STAFF REPORT

SUBJECT: AZ, PP H-2020-0112
Tetherow Crossing Subdivision

LOCATION: The site is located northeast of N. Linder Rd and W. Ustick Rd

Annexation, zoning from Ada County RUT to R-8, and preliminary plat to allow 46 building lots and 8 common lots on 7.58 acres of land.

A. Preliminary Plat (date: 11/9/2020)

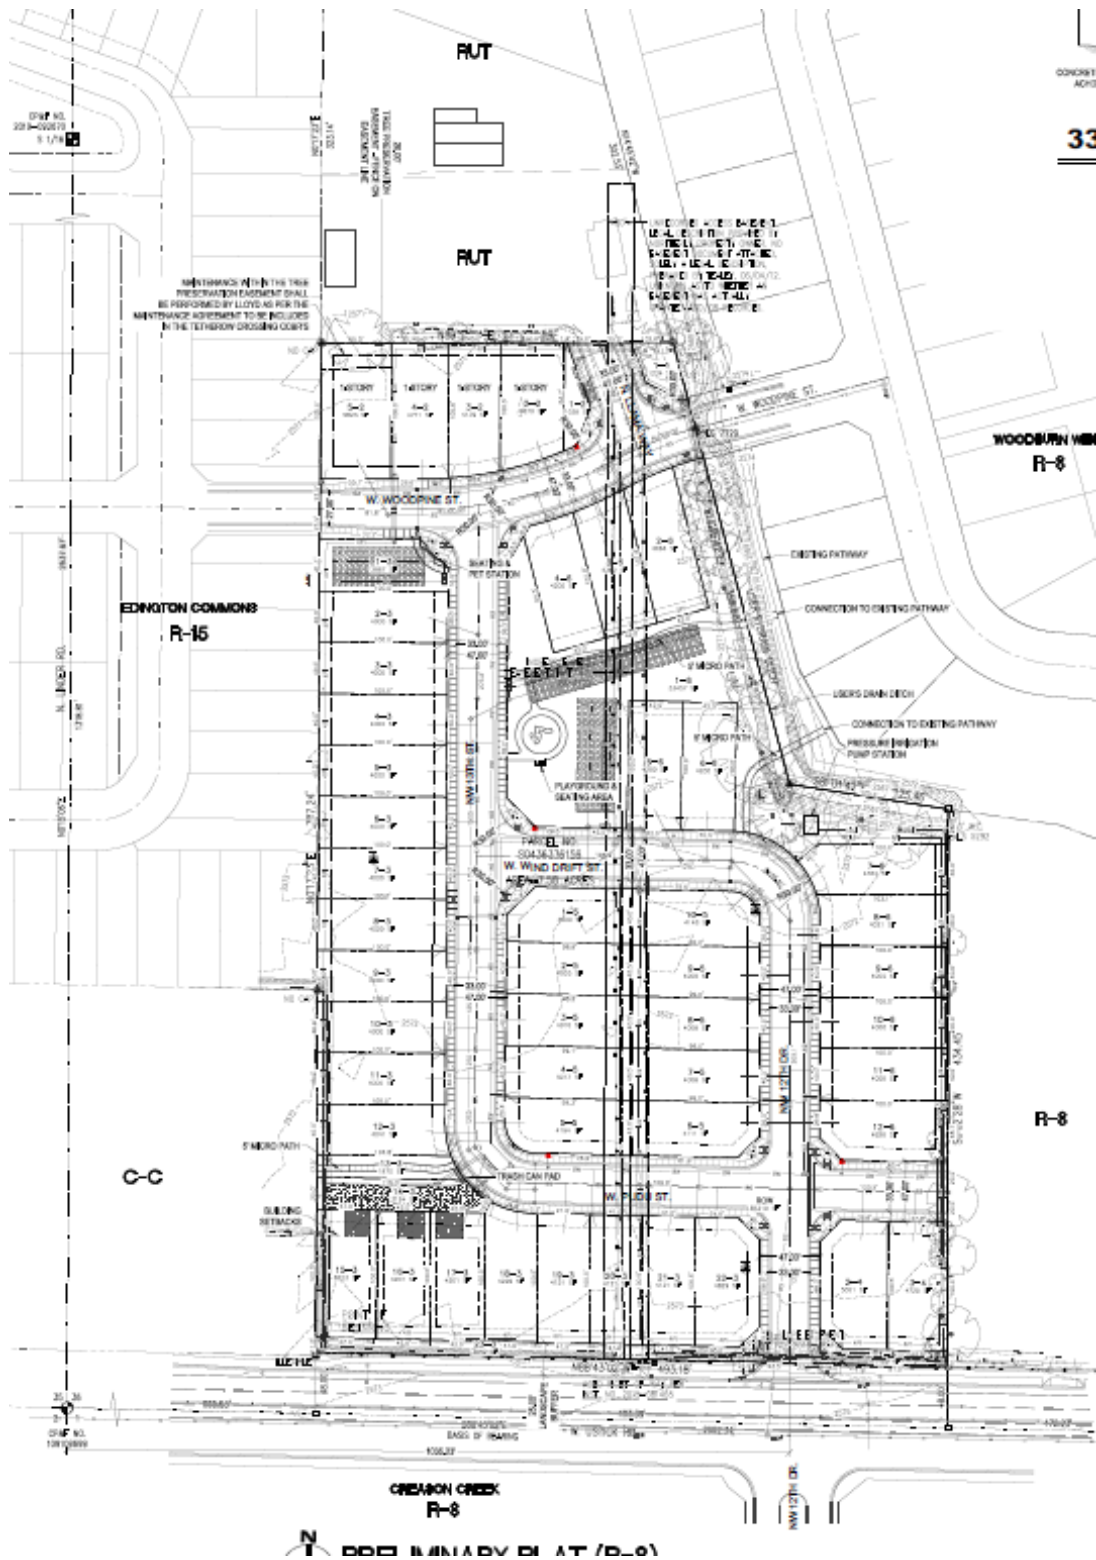
UDC 11-6C-3- regulates block lengths for residential subdivisions. Staff has reviewed the submitted plat for conformance with these regulations. The intent of this section of code is to ensure block lengths do not exceed 750 feet, although there is the allowance of an increase in block length to 1000 feet if a pedestrian connection is provided. The longest block length (Lots 2-12, Block 3) is 440 feet.

One common driveway is proposed with this subdivision. The applicant has provided a common drive exhibit which demonstrates 3 units are served whereas a maximum of 6 units are allowed. The common driveway meets the minimum width of 20' and does not exceed the maximum length of 150'. Solid fencing adjacent to common driveways is prohibited, unless separated by a minimum five-foot wide landscaped buffer. The landscape plan does reflect a 5' wide buffer to the north separating the common driveway from a 4' high solid vinyl fence with 2' lattice top. North of this fence is an approximately 18' wide common lot containing a pathway to the west.

The preliminary plat reflects an access easement across to a northern property which is not part of this subdivision, and notes it is unknown whether or not this access easement is granted or recorded. As this northern property is essentially landlocked, as a condition of approval, **staff recommends that prior to signature of the City Engineer on the final plat, a new temporary access easement be granted to this property until such time as W. Woodpine St. and N. Llama Way is constructed to the property and dedicated as public right-of-way.**

1. Additional 88 gpd committed to model.
2. Piping coming in/out of SSMH #2 needs to have a minimum angle of 90 degrees.
3. Since property to the north is not a phase of this project Road number 4 sewer line needs to end in a manhole at the northern end.

4. Water connection to the west must line up with layout of Edington Commons
5. The geotechnical investigative report prepared by GeoTek, Inc. indicate some very specific construction considerations. The applicant shall be responsible for the adherence of these recommendations to help ensure that groundwater does not become a problem within crawlspaces of homes. As noted in the Geotechnical Engineering Report, groundwater was encountered in all of the excavated test pits, ranging from 4.8' to 6.9' below ground surface. Particular attention needs to be focused on ensuring that all residences constructed with crawl spaces should be designed in a manner that will inhibit water in crawl spaces. This may include the installation of foundation drains, and the installation of rain gutters and roof drains that will carry storm water at least 10-feet away from all residences. Foundation drains are not allowed to drain into the sanitary sewer system, nor the trench backfill for the sewer and/or water service lines.

2. The Preliminary Plat included in Section VI, dated 11/9/20, is approved as submitted.
 3. With final plat submittal, the Landscape Plan included in Section VI, dated 11/9//20, shall be revised to reflect a tree preservation and mitigation plan that is approved by the City Arborist as required per UDC 11-3B-10.

B. Landscape Plan (date: 11/9/2020)

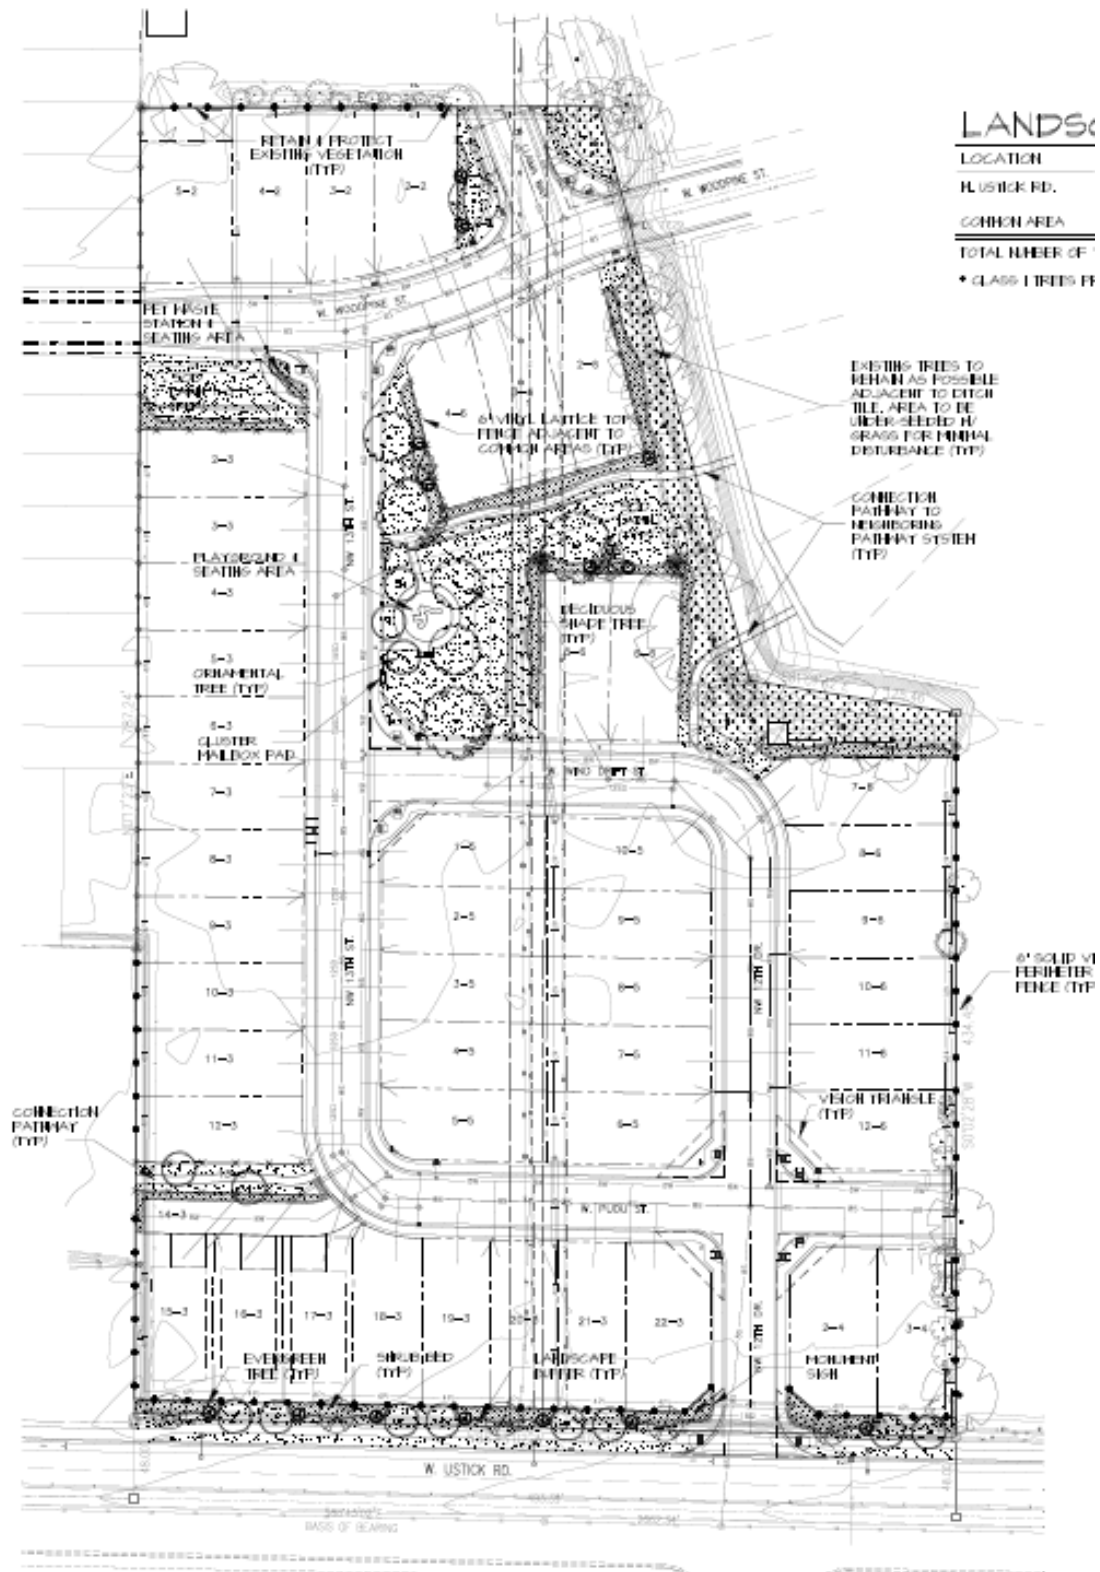
The landscape plan reflects 15.12% of total open space. This includes several small landscaped areas on either side of the N. Llama Way stub, 25' buffer along W. Ustick Rd, several pathway common lots, a central open space, and landscaping at the northeast side of the property adjacent to the ditch.

UDC 11-3B-7 requires street buffers with detached sidewalks to be measured from back of curb. As measured from back of curb, approximately 13' of the required 25' landscape buffer along W. Ustick Rd is located within ACHD right-of-way. Per UDC 11-3B-7-C5, the applicant shall be

There are existing trees that meet the requirements for preservation or mitigation, particularly in the vicinity of the ditch at the northeast portion of the property. The City Arborist has noted he has had preliminary discussions with the applicant regarding which trees should be preserved versus may be removed, although staff as of yet has not received a tree mitigation plan. This will be required with the final plat.

The landscape plan reflects existing fencing along the northwestern perimeter of the property. New 6' solid vinyl fencing is proposed along most of the remaining perimeter of the property. 6' vinyl lattice top fencing is proposed along both sides of pathway Common Lot 13, Block 3, most of the periphery of Central Park Lot 1, Block 6 except for the eastern portion adjacent to the ditch, and Common Lot 1, Block 3 (the dog station). The fencing appears to meet the requirements of 11-3A-6 and 11-3A-7.

F. Building Elevations

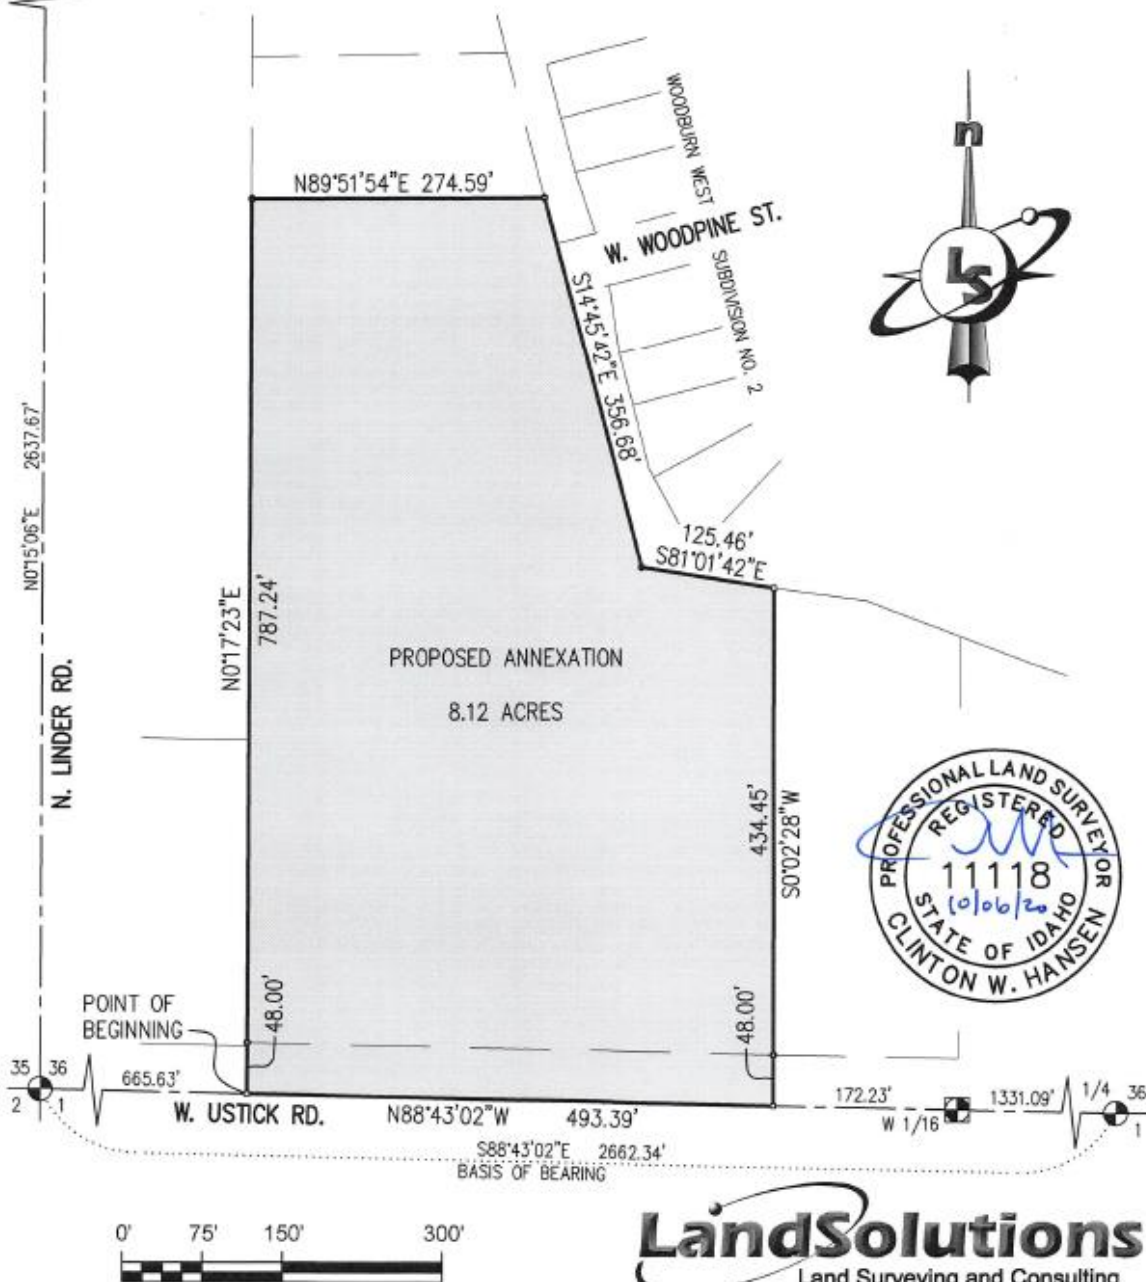
The single-family homes are depicted as two-story structures with two-car garages, and a variety of architectural elements and finish materials including gabled roofs, dormers, stone wainscoting, lap siding, exposed timber, and scalloped wood shingles. The submitted sample elevations appear to meet design requirements for single-family homes but do not include elevations of the sides or rears of structures.

As noted in the Comprehensive Plan section, some of the houses will be very visible from W. Ustick Rd. Therefore, staff recommends a condition that the rear and/or sides of 2-story structures on Lots 15-22 of Block 3 and 2-3 of Block 4 that face W. Ustick Rd. incorporate articulation through changes in two or more of the following: modulation (e.g. projections, recesses, step-backs, pop-outs), bays, banding, porches, balconies, material types, or other integrated architectural elements to break up monotonous wall planes and roof lines. Single-story structures are exempt from this requirement. Planning approval will be required at time of building permit.

- b. The rear and/or sides of 2-story structures on Lots 15-22 of Block 3 and Lots 2-3 of Block 4 that face W. Ustick Rd. shall incorporate articulation through changes in two or more of the following: modulation (e.g. projections, recesses, step-backs, pop-outs), bays, banding, porches, balconies, material types, or other integrated architectural elements to break up monotonous wall planes and roof lines. Single-story structures are exempt from this requirement. Planning approval will be required at time of building permit.
